MOONEY AIRCRAFT, INC.

Service Letter 20-16  
**SERVICE BULLETIN M 20-16**

DATE: 9-21-56  
SUBJECT: Kit - Baggage Straps  
REASON: To comply with C. A. A. Regulations  
MODELS AFFECTED: M-20 Serial Nos. 1002 thru 1020  
TIME OF COMPLIANCE: As soon as possible  
PARTS LIST:  
3302-1 (2) AN3-5A (4)  
3302-2 (2) AN960-10 (2)  
AN970-4 (4) AN365-1032 (2)  
ENCLOSURE: Notice of compliance card.

VIEW LKG DOWN AT BAG FLOOR  
FIG. 1

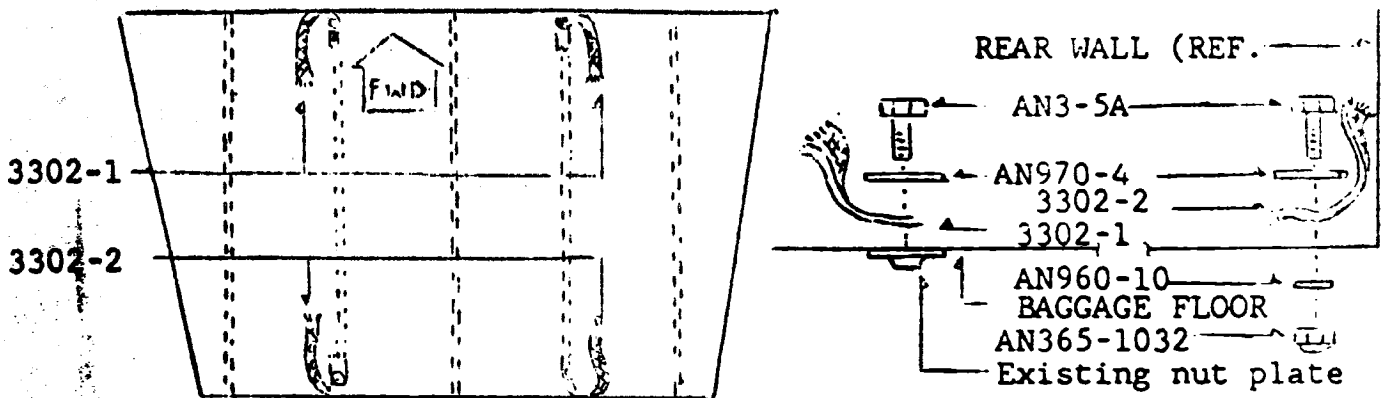
1. Remove access panel from lower wing (large panel with three inspection rings) below baggage compartment floor.
2. Remove baggage floor mat and bolt next to center bolt on each side at front of baggage floor (see Fig. 1). Discard these bolts.
3. Install 3302-1 as shown in Fig. 2.

4. Drill out first rivet forward of rear wall of baggage compartment next to center row on each side with #12 (.189)D drill and install 3302-2.
5. Drill floor mat temporarily and mark slots to be cut in mat forward of front strap attachments and just aft of rear strap attachments. Remove mat, cut slots, and replace mat inserting straps through slots.
6. Replace access panel on lower wing.
7. Return notice of compliance card properly filled out and signed. Installation is now complete.
